Data Set: C:\Users\trevora\Documents\2021_Moves\27188_ID5\27188 Current.aqt
 Date: 11/19/21 Time: 16:34:19

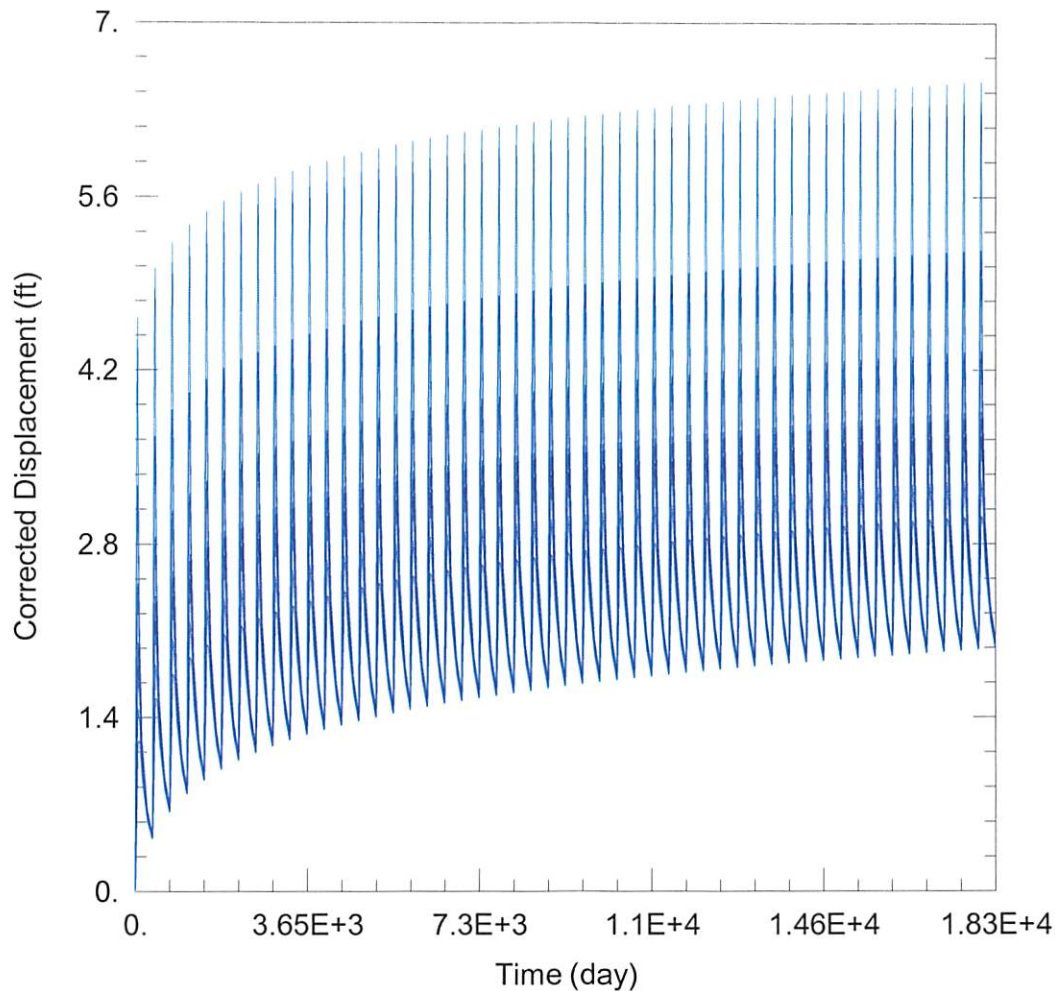
The proposed move is likely to create noticeable effects on neighboring wells 27188 ID2 and 27188 ID4. 27188 ID2 was identified as a critical well because it is projected to lose more than 40% of its remaining usable water supply over the next 25 years. Both of these wells are owned and operated by the applicant. GMD3 staff recommends approval of the application.
